RE: **PETITION NO. 1527** – The Connecticut Light and Power Company d/b/a Eversource Energy declaratory ruling, pursuant to Connecticut General Statutes §4-176 and §16-50k, for the proposed Stevenson to Pootatuck Rebuild Project consisting of the replacement and reconductoring of electric transmission line structures along approximately 8 miles of its existing Nos. 1560, 1808 and 1580 115-kilovolt (kV) electric transmission lines within existing Eversource electric transmission line right-of-way between Eversource's Stevenson Substation, 1 Roosevelt Drive in Monroe and The United Illuminating Company's Pootatuck Substation, 14 Old Stratford Road in Shelton, Connecticut, and related electric transmission line and substation improvements.

RE: Petition No.1527 – Stevenson to Pootatuck Rebuild Project
Two Structure Shifts in Shelton

Enclosure: Revised Attachment A - Map Sheet 14

EVERSOURCE					
Stevenson to Pootatuck Rebuild Project					
Shelton, CT			Map Sheet 14 of 14		
Date: April 04, 2023					
NO.	DATE	REVISIONS	BY	CHK	APP

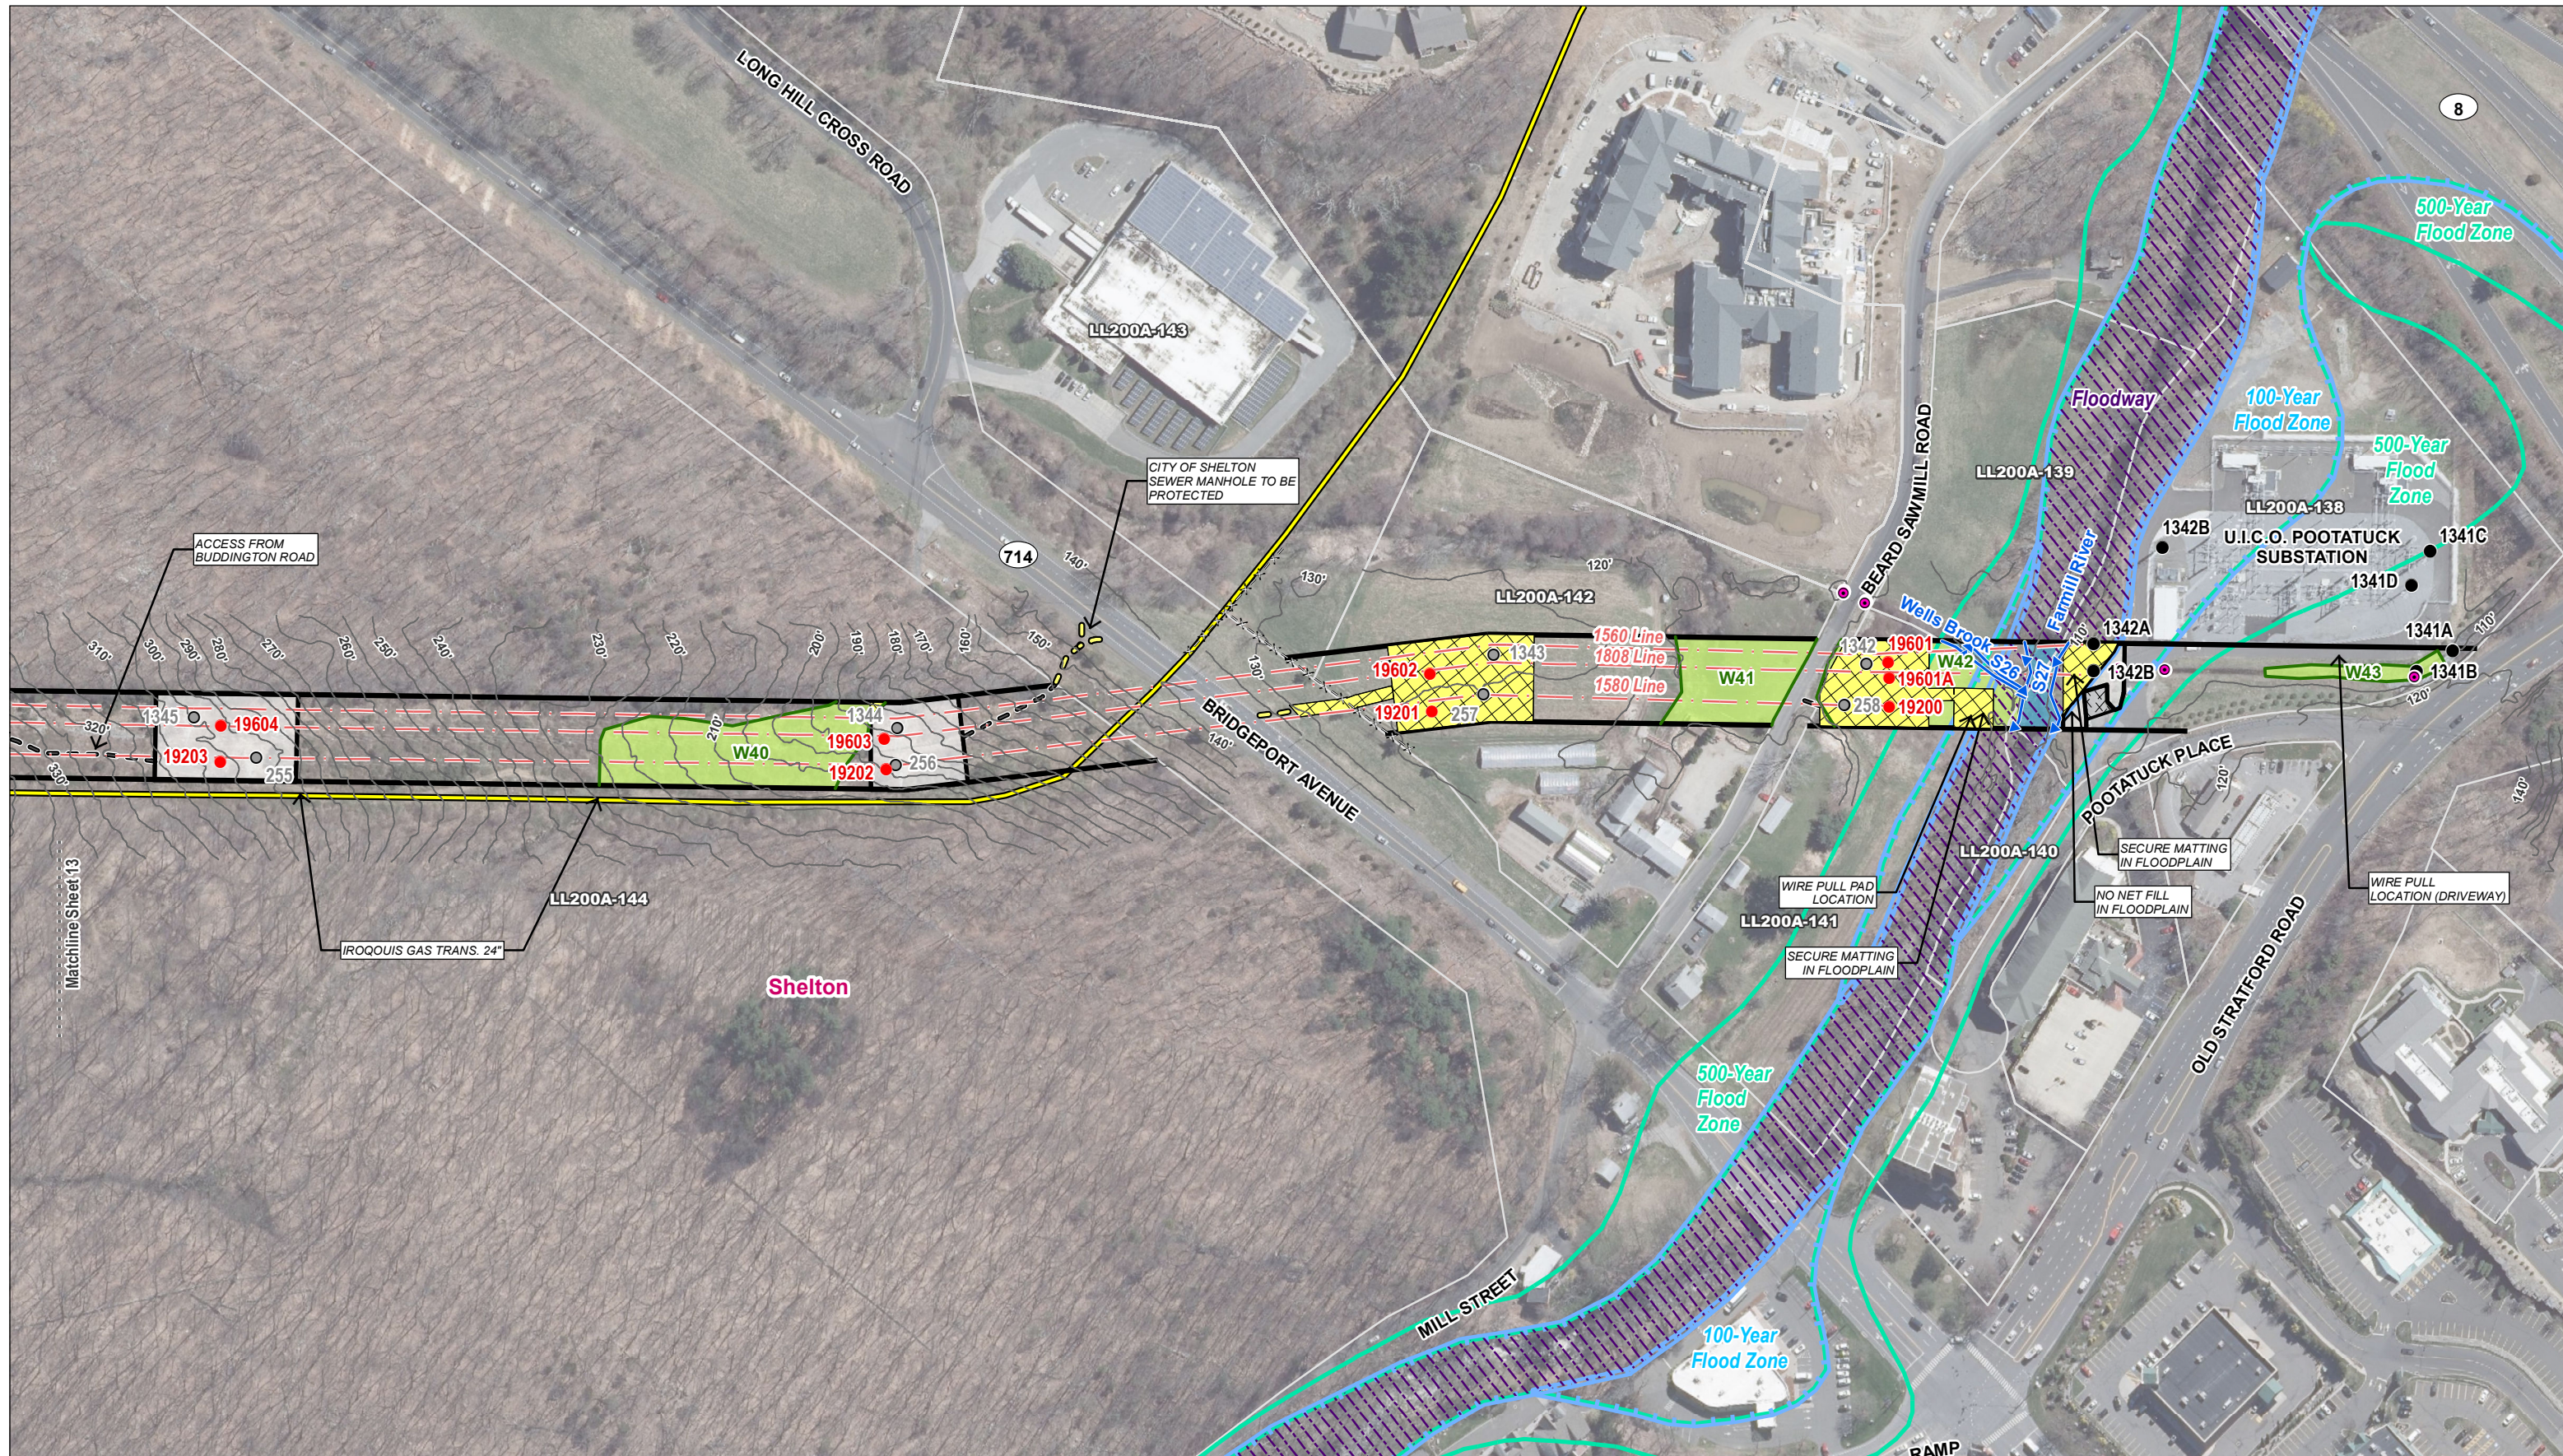
Since the time of the Council's ruling, Eversource has determined that civil construction of the work pad for Structures 19202 and 19603 requires a significant cut to the existing slope creating a concern for the integrity of the existing Structure 256 during construction activities. To alleviate this concern, Eversource is proposing to shift the location of both structures approximately 50 feet north of its originally proposed location and remaining on the existing work pad. (See revised Attachment A - Map Sheet 14). In addition, the proposed modifications to structure shifts will not result in any additional environmental effects as presented in the Petition.

The Connecticut Siting Council (Council) is in receipt of your correspondence dated April 4, 2023 regarding project changes to the above-referenced Declaratory Ruling issued by the Council on December 9, 2022. The proposed project changes include shifting the location of Structure Nos. 19202 and 19603 approximately 50 feet to the north within the footprint of the approved work pad to avoid earthwork that could destabilize existing Structure No. 256.

Pursuant to Condition No. 1 of the Council's December 9, 2022 Declaratory Ruling, the requested project changes are hereby approved. This approval applies only to the project changes described in the April 4, 2023 correspondence.
